UCRL-AR-136189

**Explanation of Significant Differences for the  
Trailer 5475 Ground Water Remediation,  
Lawrence Livermore National Laboratory,  
Livermore Site**

**February 2000**

Figure 2. Current treatment method for VOCs in the Trailer 5475 area.

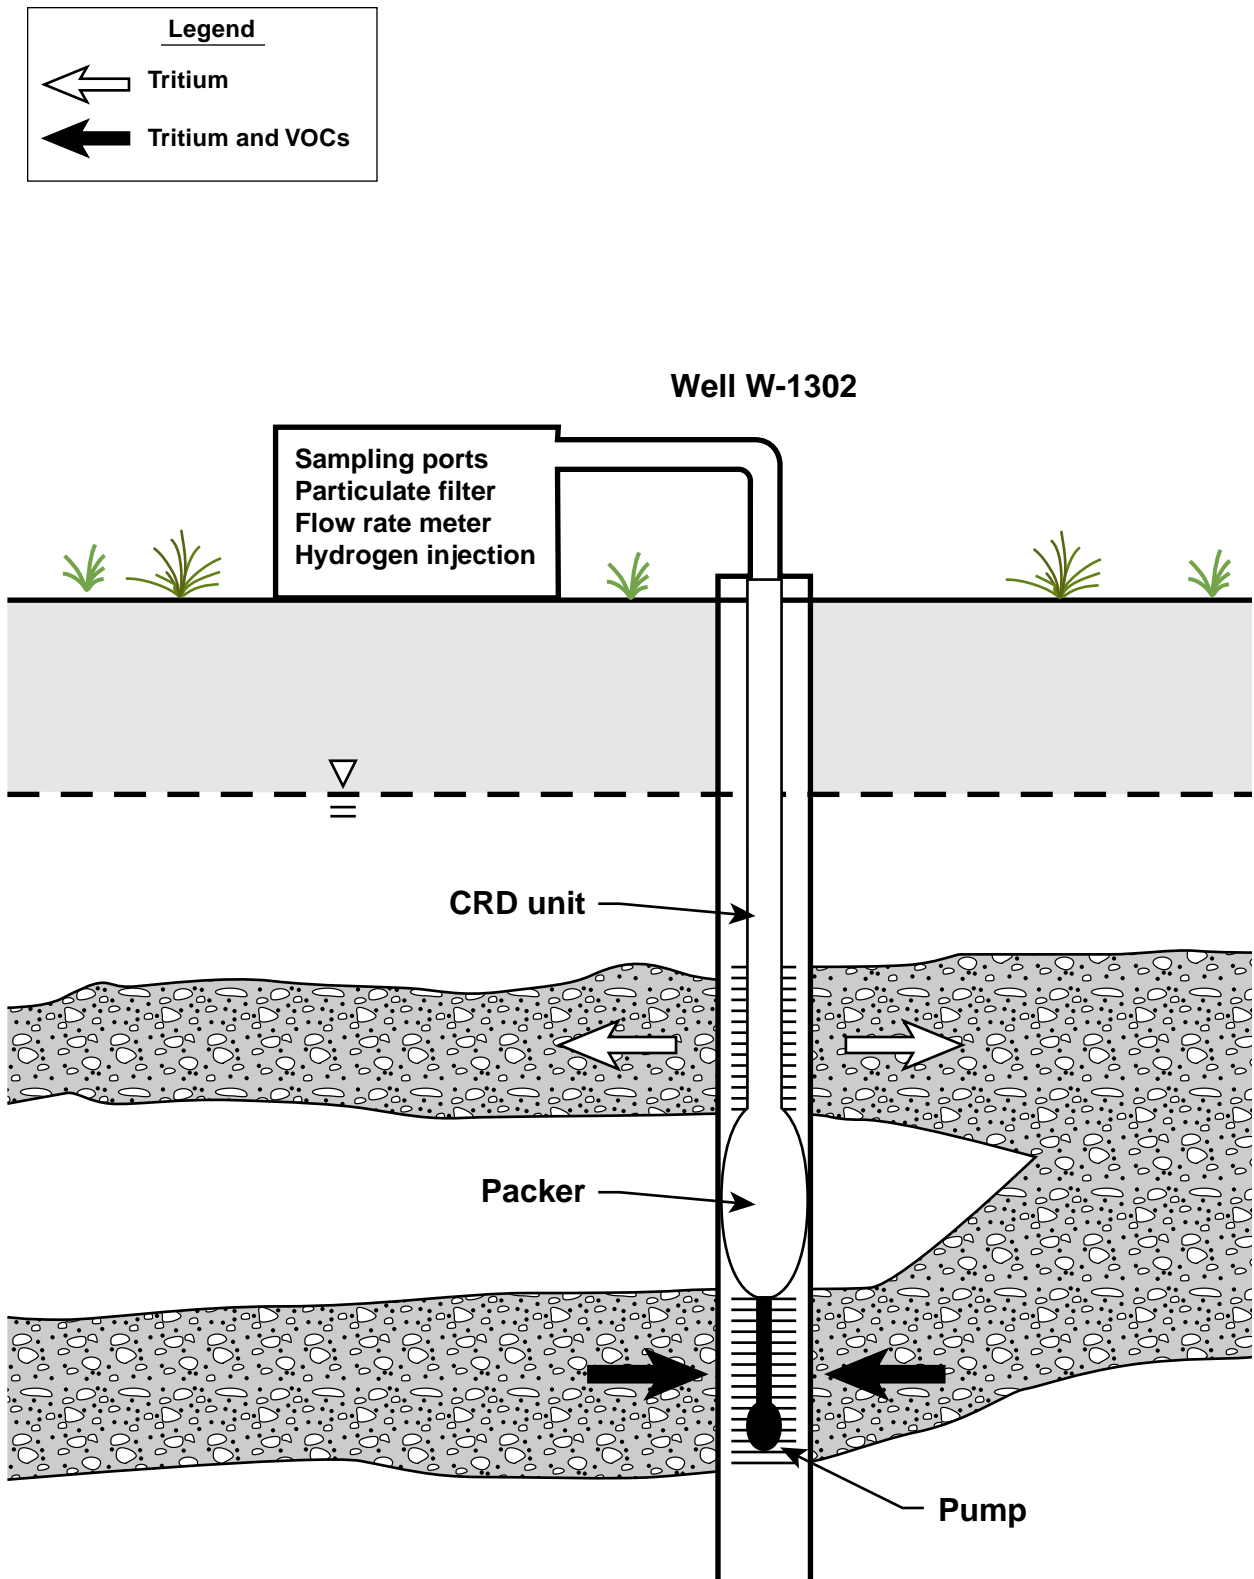
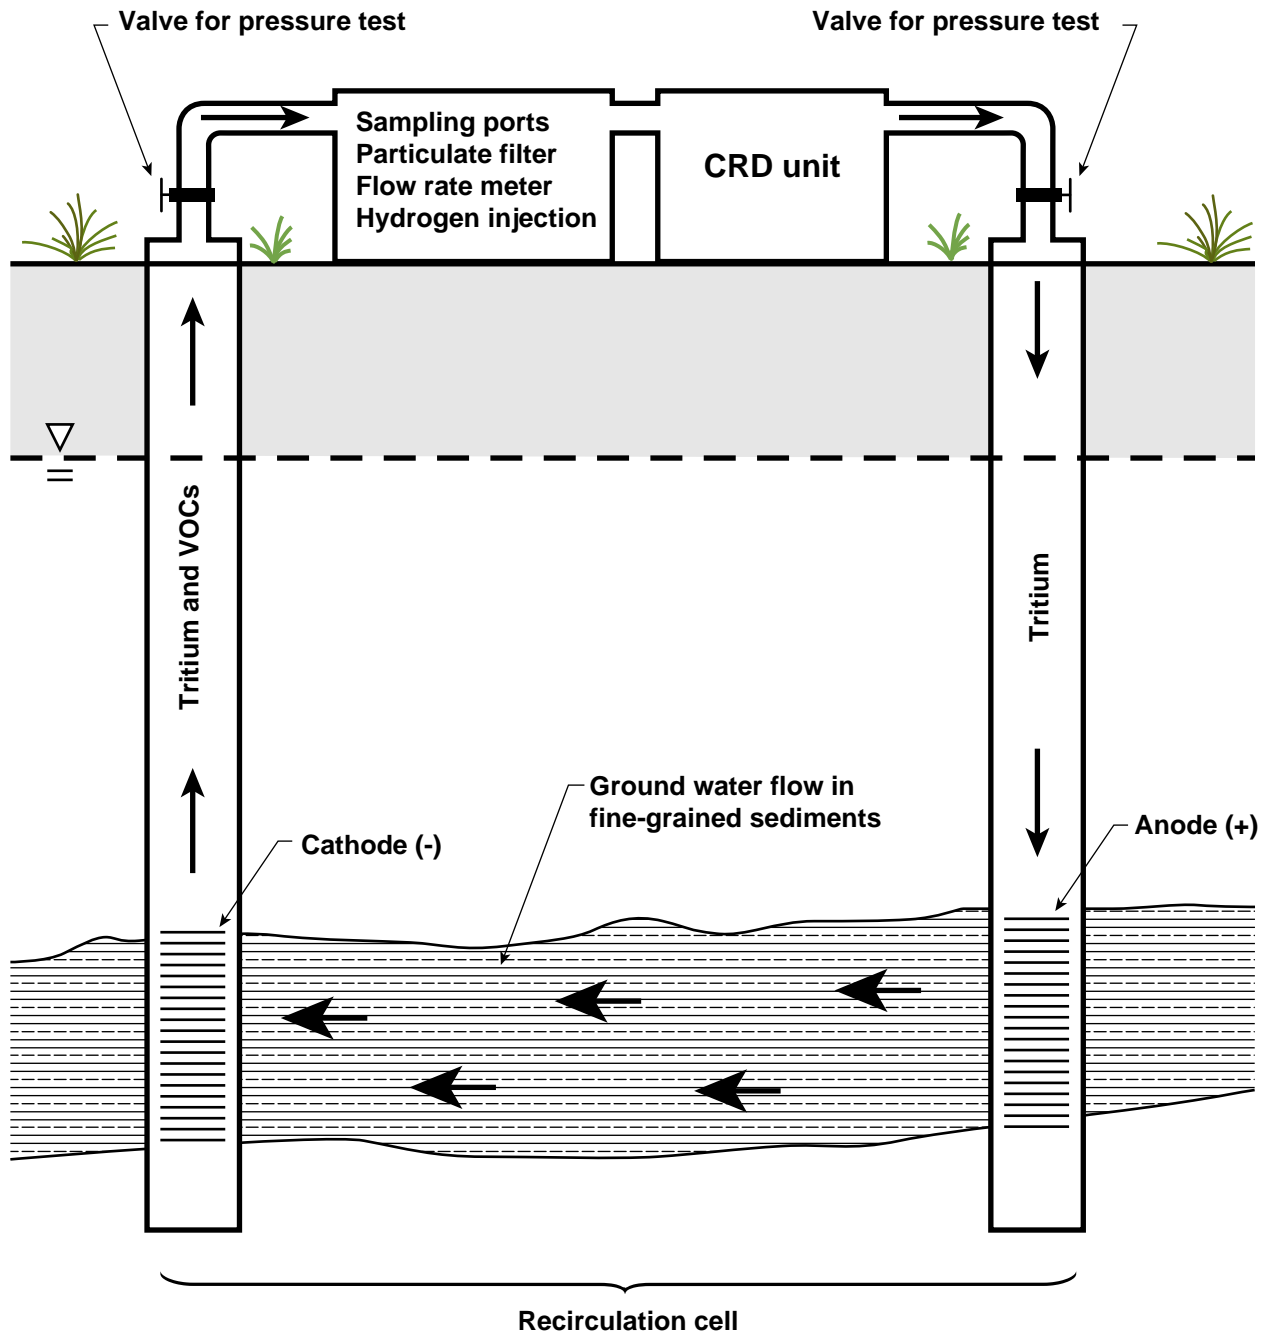
At the time of the ROD, there was no technology identified to treat the VOCs *in situ* in the presence of tritium. Since the ROD, DOE/LLNL, in conjunction with Stanford University, conducted experiments based on catalytic reductive dehalogenation (CRD) of dissolved VOCs by hydrogen in the presence of a palladium catalyst. After these experiments, LLNL designed a treatment system that was approved by the regulatory agencies in a Remedial Design Report for the Trailer 5475 area (Berg et al., 1998). The design had a treatment column placed down a well with screened intervals in two sand units within a single hydrostratigraphic unit. This downhole treatment method meets the conditions of the ROD, but only captures VOCs in a limited area adjacent to the well, is only effective for very low flow rates (about 1-2 gallons per minute [gpm]), and requires being shutdown overnight to allow the catalyst to regenerate. In addition, recent hydrogeologic analysis suggests that the geological characteristics (two sand bodies within the same hydrostratigraphic unit) needed to deploy a system similar to the original design are not present in all areas requiring VOC remediation in the Trailer 5475 area.

To make this treatment method more effective (e.g., increase flow rates, increase the area of influence, and operate 24 hours per day), DOE/LLNL propose to construct a closed loop system with a CRD treatment unit at the surface. The ground water containing both VOCs and tritium above MCLs will be pumped to the surface where over 90% of the VOCs will be destroyed by CRD, and then the remaining tritiated water will be reinjected back to the subsurface into the same hydrostratigraphic unit from which it was extracted. This change departs from the language in the ROD, yet still follows the primary intent to keep the tritium in the subsurface to decay naturally. The basis for this change is discussed in Section 3.2.

- There will be a greater area of cleanup in the proposed remedy as the ground water is extracted from one well and injected into another, creating a horizontal recirculation cell (Fig. 3). The recirculation cell created from the current remedy is smaller and more localized because it is only generated between the two screened casing intervals within a single well (Fig. 2).

**Figure 3. Proposed treatment method for VOCs in the Trailer 5475 area (shown in conjunction with electro-osmosis).**

- DOE/LLNL plan to use the CRD technology in conjunction with electro-osmosis (EO) (Fig. 3). The EO design will have electrodes in the wells to promote the movement of contaminated pore water in fine-grained sediments under the influence of an electric field. The contaminated pore water will move through the fine-grained sediments to the extraction wells, and will then be treated by CRD to destroy the VOCs. Removing VOCs from the fine-grained sediments is vital to achieving timely cleanup of the Trailer 5475 area. The electrodes in the wells will take up space normally occupied by the CRD unit. An aboveground CRD unit will simplify the design and installation, and can also be sized to simultaneously treat ground water from multiple extraction wells. DOE/LLNL plan to initially operate the system at about 3 gpm, and may eventually operate at about 10 gpm as additional extraction wells are connected.
